Facilities & Operations Committee
Meeting September 2026
Tuesday, September 22, 2026 6:43 PM Eastern

RE: North Penn High School BP-2
Change Order Request #23 ASI 01 – Additional Shaft wall

RE: North Penn High School BP-2
Change Order Request #25 AV Wall Change ASI #16

RE: North Penn High School BP-2
Change Order Request #28 ASI #3 – Courtyard Revisions

Drawing Number:
BP2-A122.A1

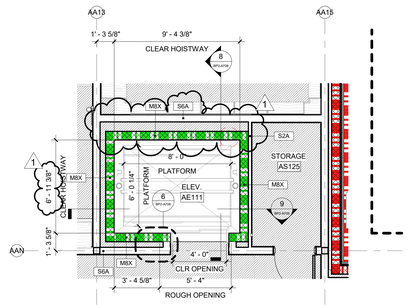
Revisions to Architectural Set:
- Drawing BP2-A122.A1; REPLACE sheet in its entirety (attached). Height of pendant lighting from Second Floor elevation to bottom of fixture provided.
- Drawing BP2-A121.E; CLARIFICATION that 6A WOOD CELING SYSTEM direction in LIBRARY E155 to run short distance to align with lighting.
- Drawing BP2-A708; REPLACE sheet in its entirety (attached). Revise ELEV1 hoistway plan dimensions, layout, and associated head and jamb details.

Drawing Number:
BP2-A708

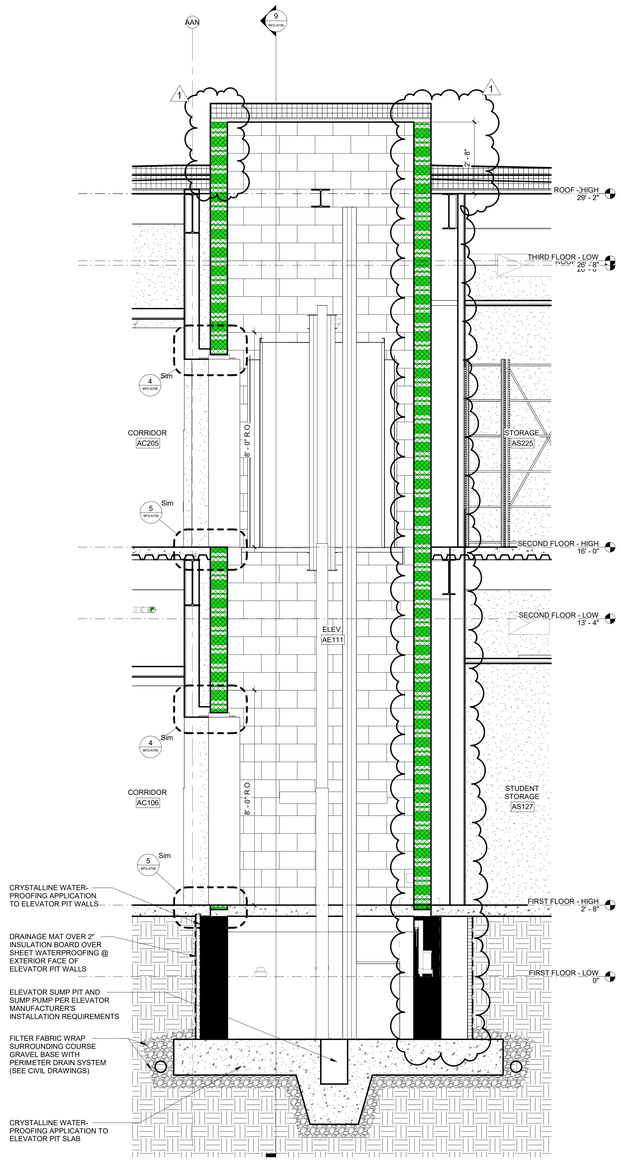
Please see below the costs associated with the changes listed in ASI 01, issued 01-26-2026. This proposal includes providing and installing an added Layer of 1" Shaft Liner to Elevator Doors per Details 4 and 6/BP2-A708.

- **Added Layer of 1" Shaft Liner to Elevator Doors per Details 4 and 6/BP2-A708 of ASI-001.**

Revisions to Structrual Set:
- Modifications to structural steel framing adjacent to elevator shaft shall be made per revised sheet BP2-A708 and reflected on Revise & Resubmit For Record submittals.

Drawing Number:
BP2-A111.A2

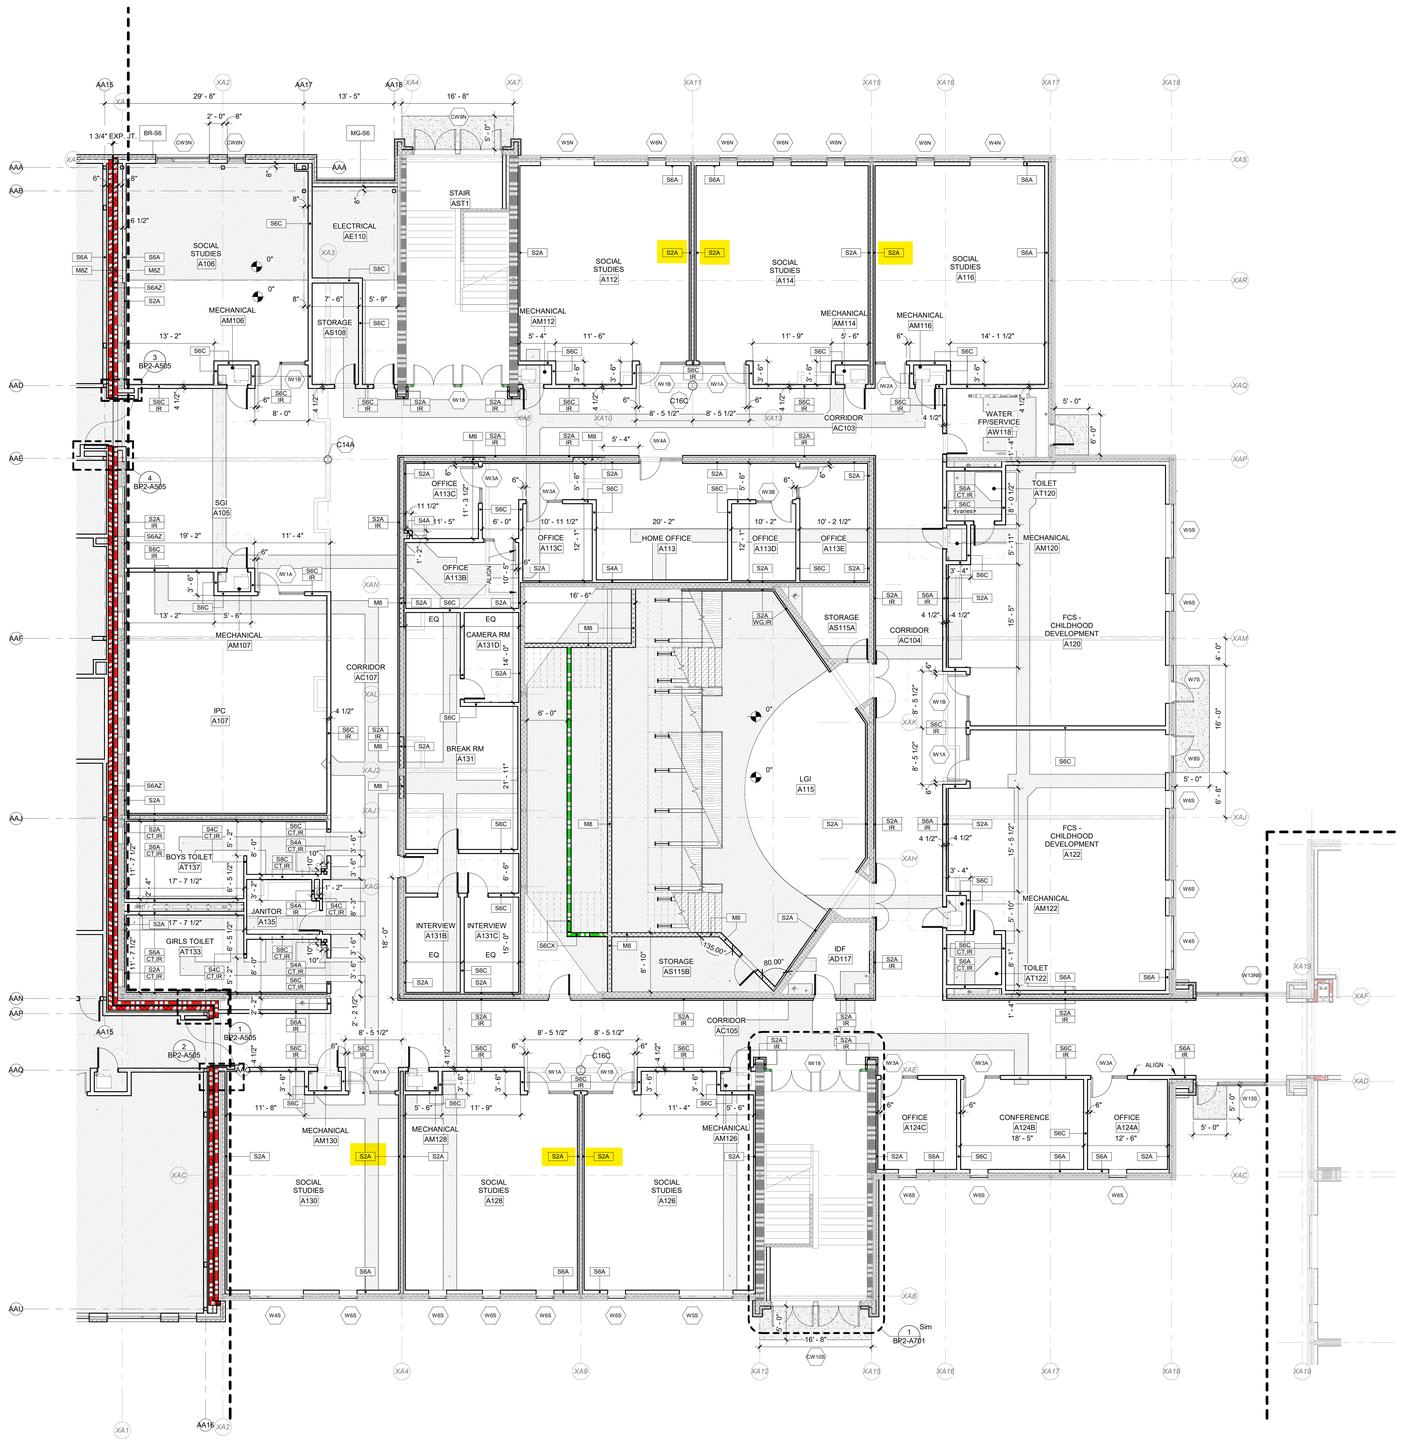
16.01 Architectural BP2-A110 Series Drawings: Revise Classroom AV wall partition type to S4A in lieu of S2A.

Drawing Number:
BP2- C039

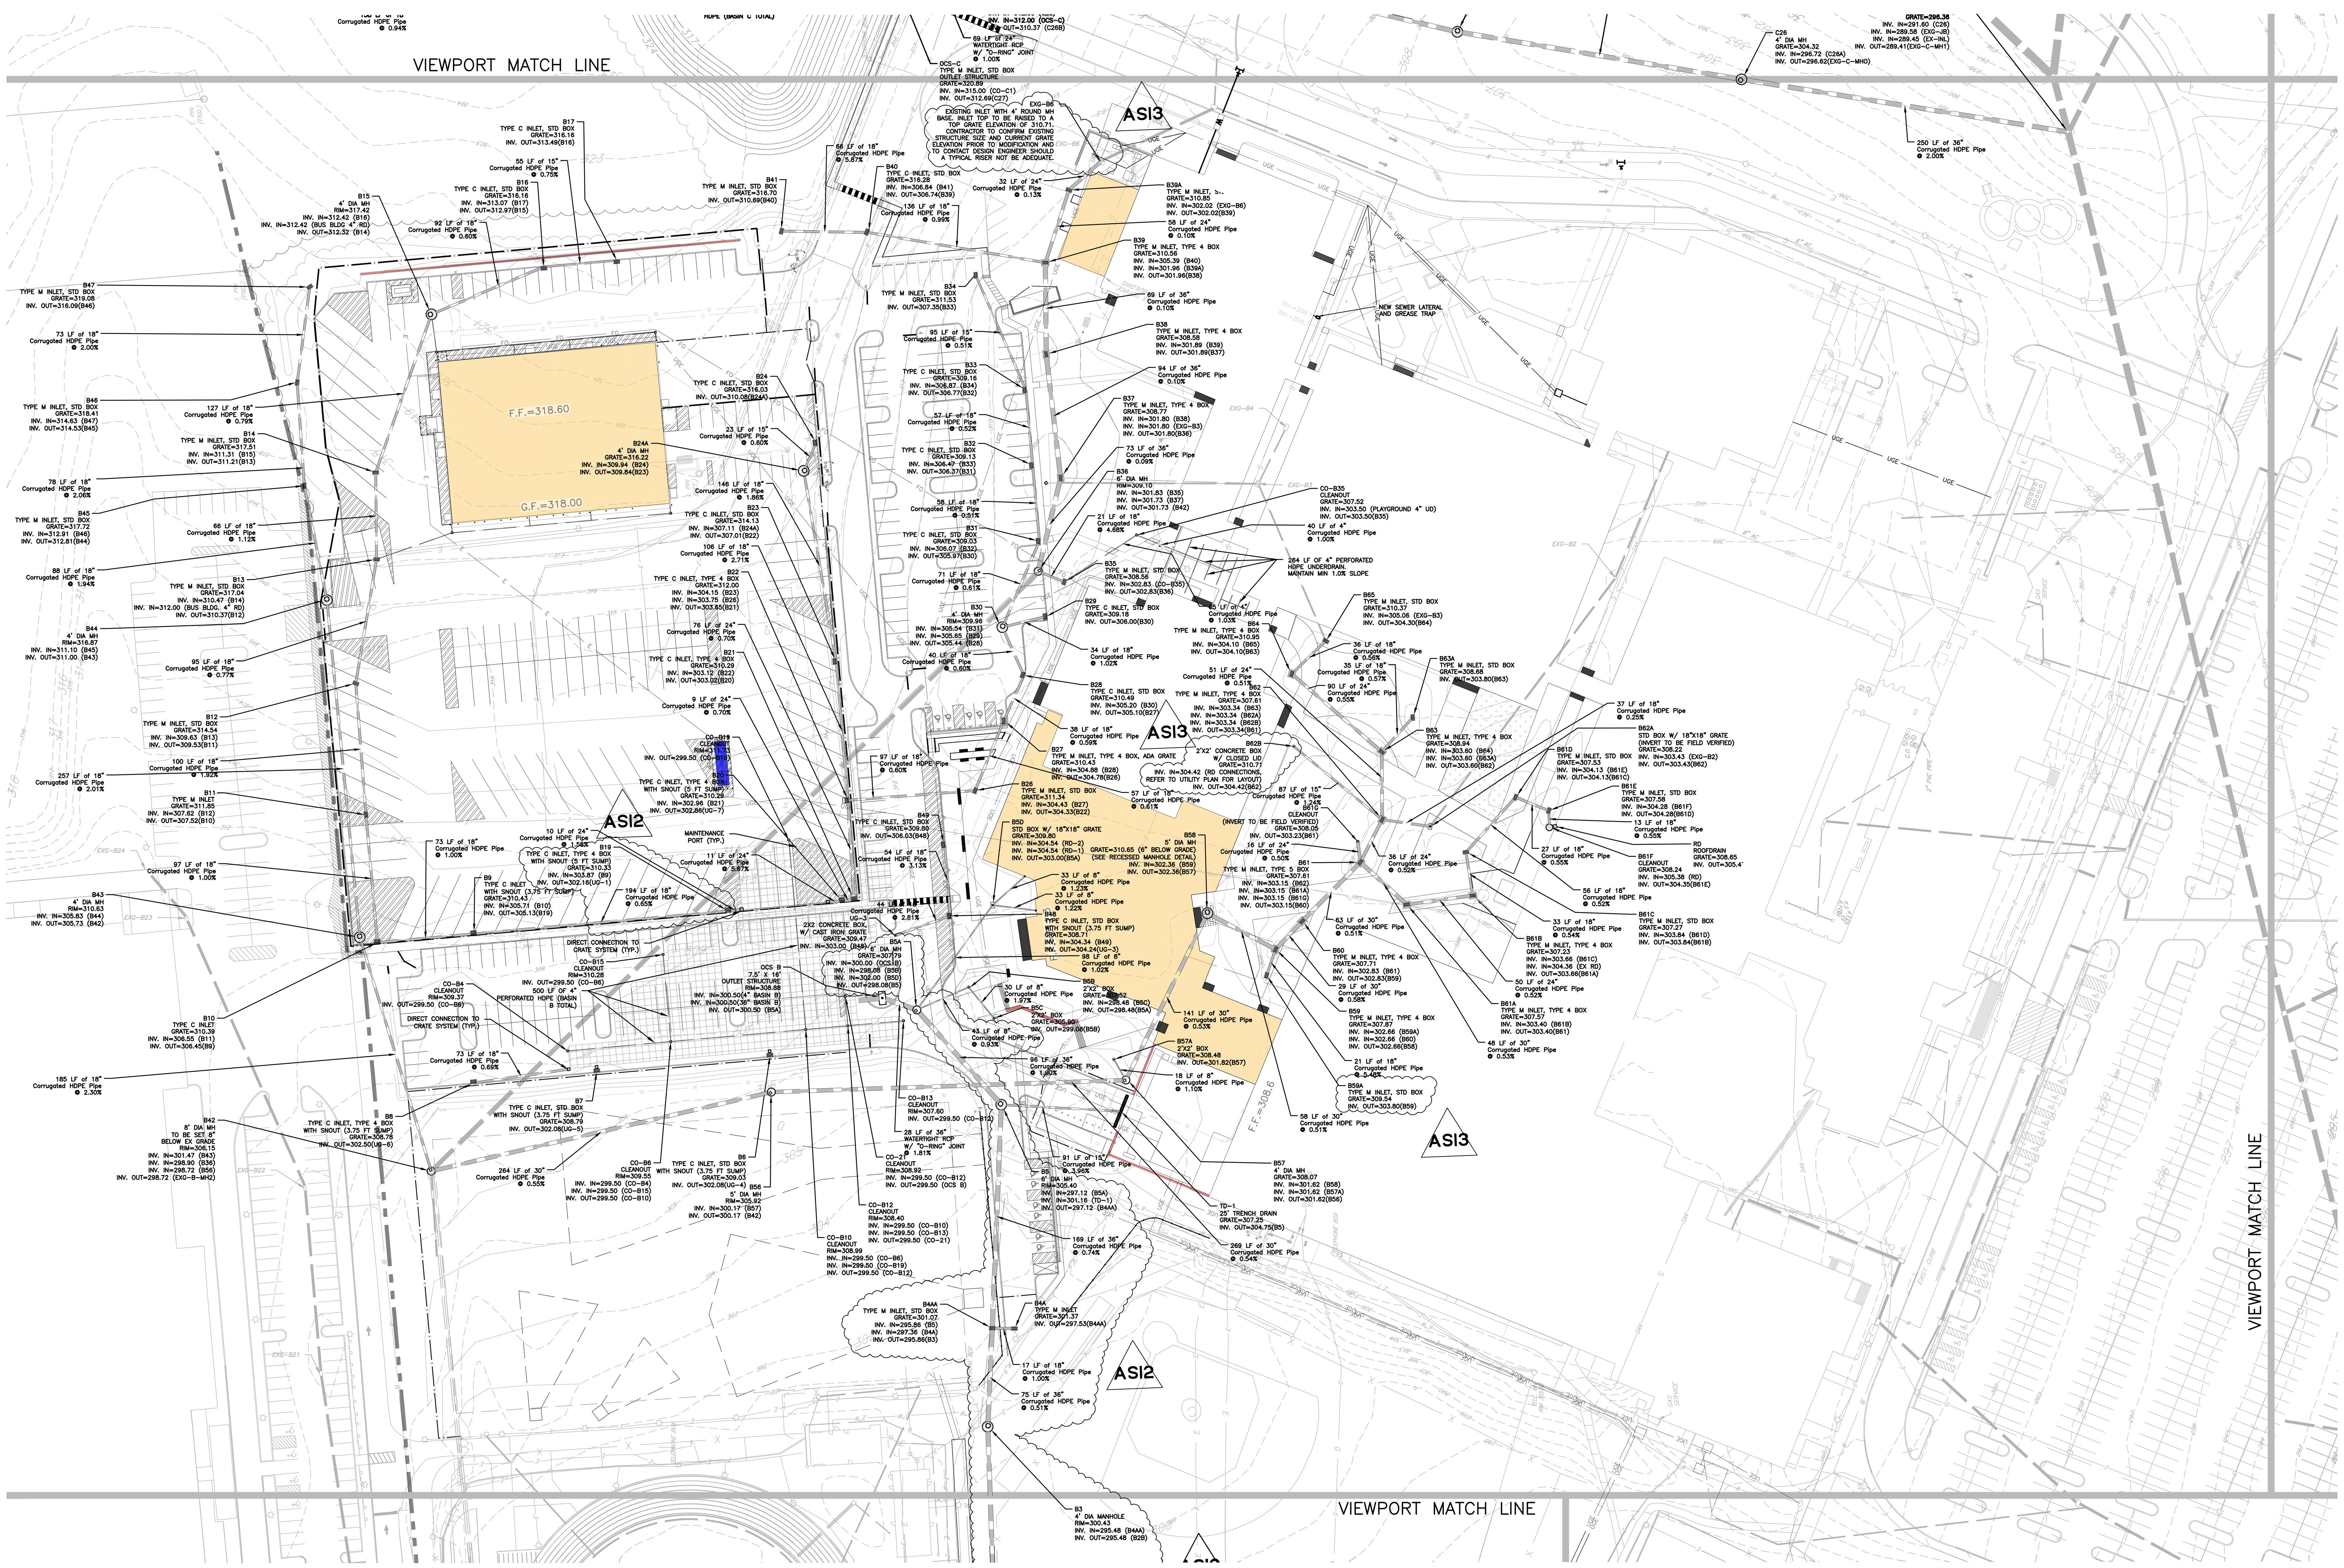
5. Courtyard Detailed Plan (BP2-C039) has been modified to make plan revisions including but not limited to:
   - **To revise proposed courtyard hardscape footprint and retain existing generator.**
   - **To revise extents of concrete path near the Southwest entrance(s) to the interior courtyard.**

Drawing Title:
EXTERIOR STAIR DEMOLITION

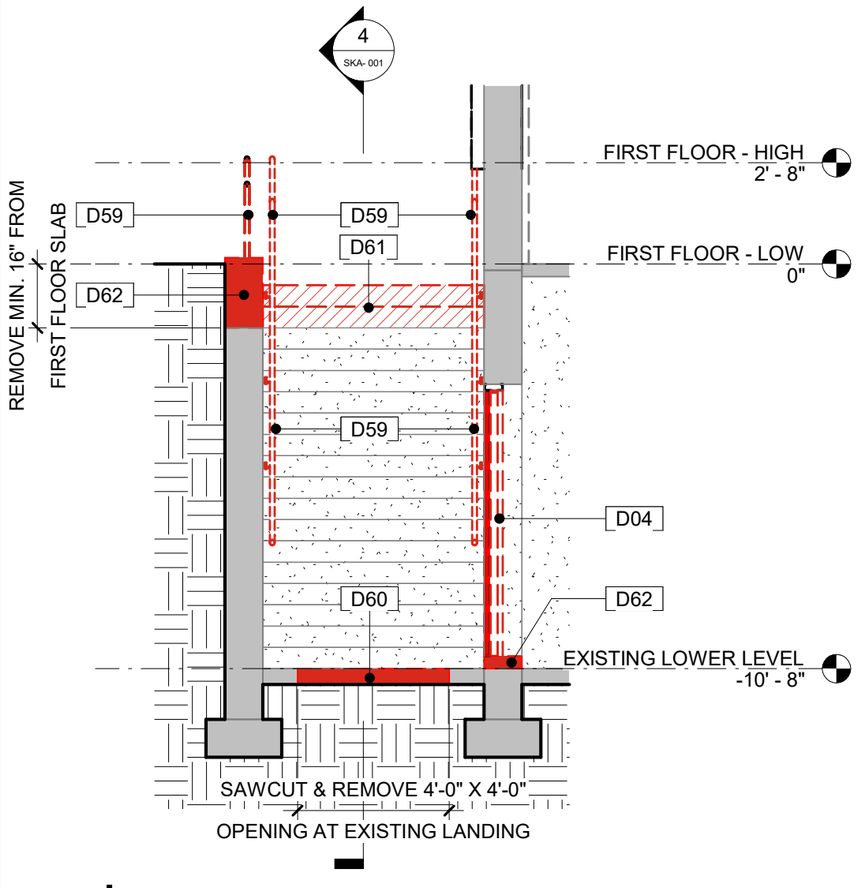
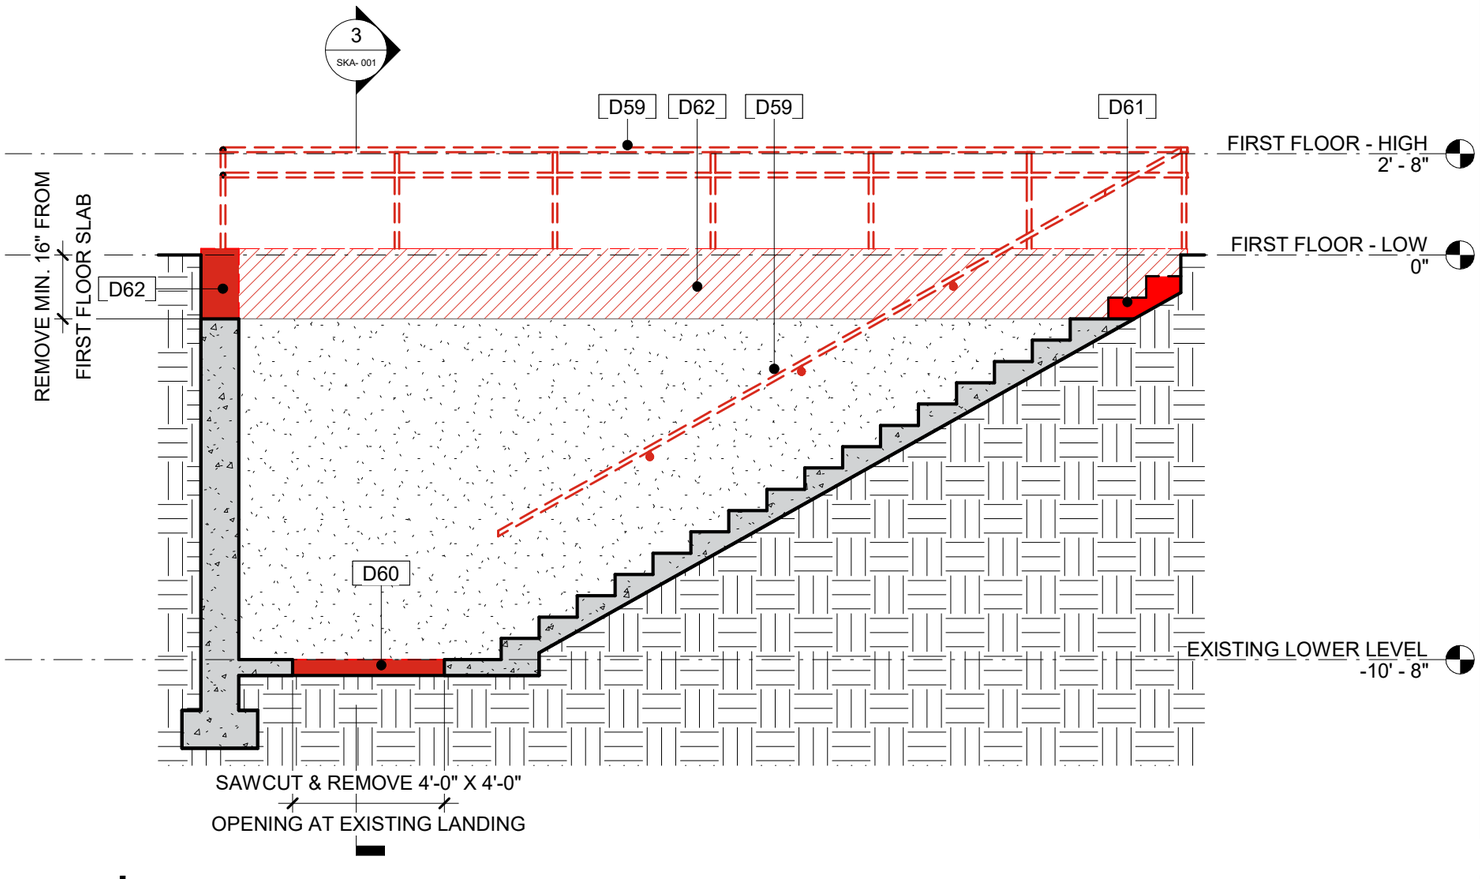
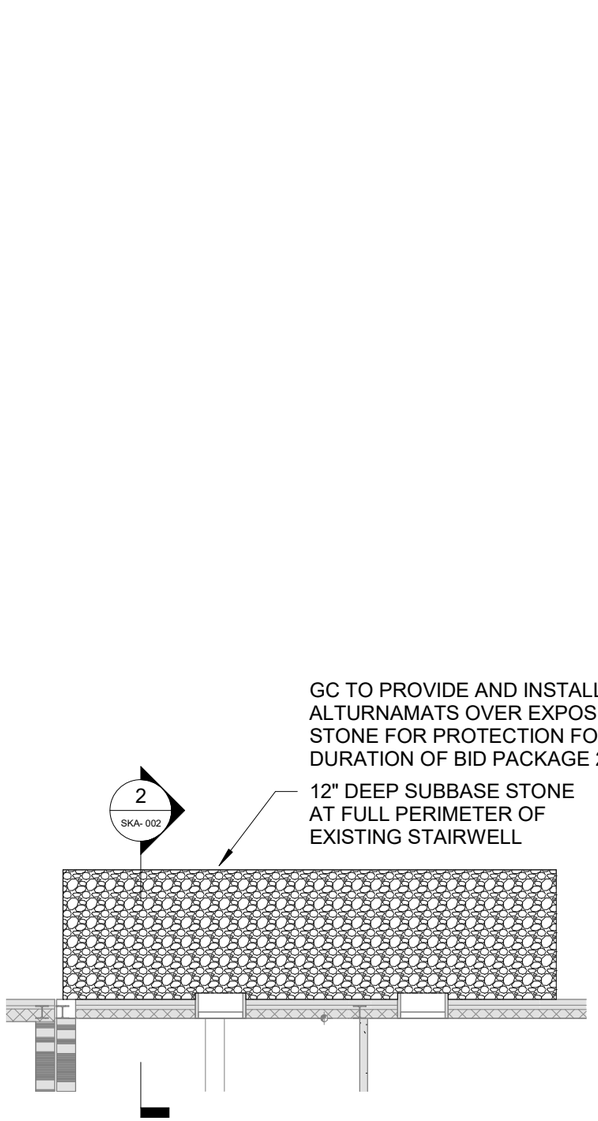
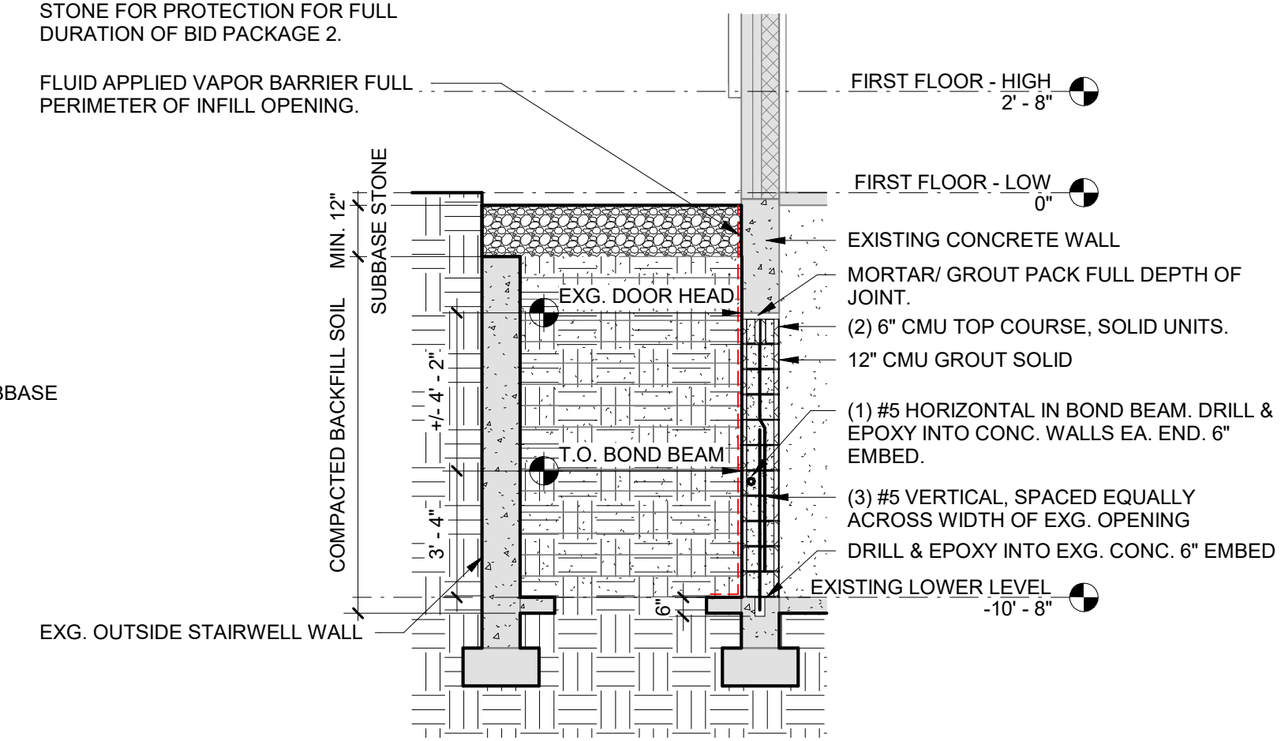
EXTRA WORK/CHANGE DESCRIPTION:
Hammer Steps and Wall below grade, leave in place to be buried. Hammer bottom of stairs to allow drainage.
NO MATERIAL WILL BE REMOVED FROM SITE. BACKFILLING OF STAIRS IS NOT INCLUDED IN THIS PRICE
NO SAW CUTTING IS INCLUDED. Surface will be rough as they will be broken off and not neatly removed.

ASI 03.1GC: Courtyard Grading Revisions (Per RFI GC-008 Courtyard Grading)
ASI 03.2GC: H-Pod Stairwell Demolition & Infill
ASI 03.3GC: Area B Equipment Yard Storm Inlet & Concrete Paving

BP2-CSKE-10 SCALE: 1/8" = 1'-0"

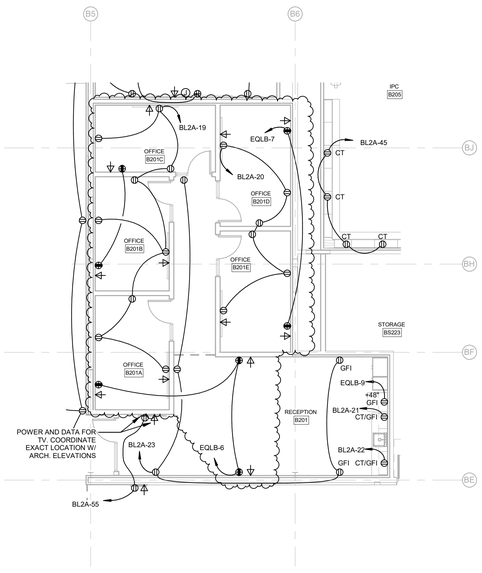
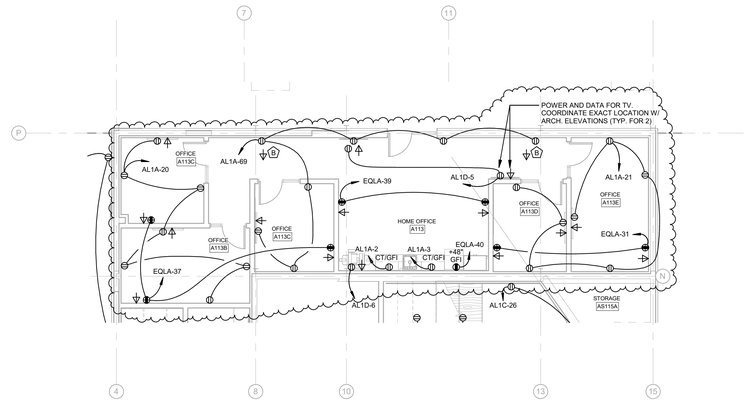
14.03 Sketch BP2-CSKE-10; **ADD** sketch BP2-CSKE-10 dated 06/18/2026.
